Intersection ID: 49893	Main Street: ROCKY_FORD_CLUB_RD	Cross Street: RIDGEVIEW_COMMONS_DR	Location:	N
ADA ID: 20201E9F53D7	Ramp Type: PerpDiag	Initial Pass/Fail: Fail	Overall Compliance: No	Severity Score: 10

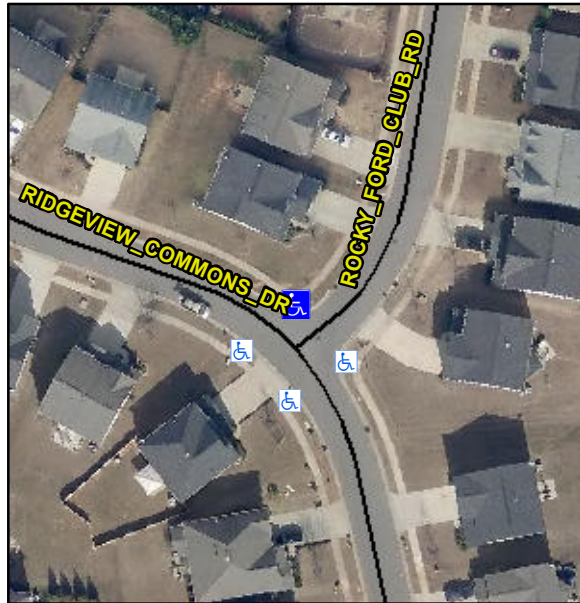
Not Found, R304.5.1, R304.5.3

Compliance	Description	Data	Compliance	Description	Data
N/A	Ramp Length (in)	70.0	Yes	Ramp Slope (%)	5.9
No	Ramp Width (in)	39.0	No	Ramp XSlope (%)	3.7
N/A	Flare Type LT	N/A	N/A	Flare Type RT	N/A
N/A	Flare Slope LT (%)	N/A	N/A	Flare Slope RT (%)	N/A
N/A	Flare Traversable LT?	N/A	N/A	Flare Traversable RT?	N/A
N/A	Landing Length (in)	N/A	N/A	DWS Provided?	N/A
N/A	Landing Width (in)	N/A	N/A	DWS Contrast?	N/A
N/A	Landing Slope (%)	N/A	N/A	DWS Length (in)	N/A
N/A	Landing X Slope (%)	N/A	N/A	DWS Full Width?	N/A
N/A	Landing Curb? (Y/N)	N/A	N/A	DWS Offset (in)	N/A
N/A	Shared Landing?	N/A			
N/A	Gutter Ponding?	N/A	N/A	Gutter Slope (%)	N/A
N/A	Gutter Lip Ht (in)	N/A	N/A	Gutter X Slope (%)	N/A
N/A	Painted X Walk1?	No	N/A	Painted X Walk2?	No
	X Walk 1 Direction	To SW		X Walk 2 Direction	To SE
N/A	X Walk 1 Width (in)	N/A	N/A	X Walk 2 Width (in)	N/A
	X Walk 1 Slope (%)	1.2		X Walk 2 Slope (%)	0.5
	X Walk 1 X Slope (%)	2.2		X Walk 2 X Slope (%)	2.0

Remove & Replace Curb Ramp With Two New Directional Ramps or Equivalent.
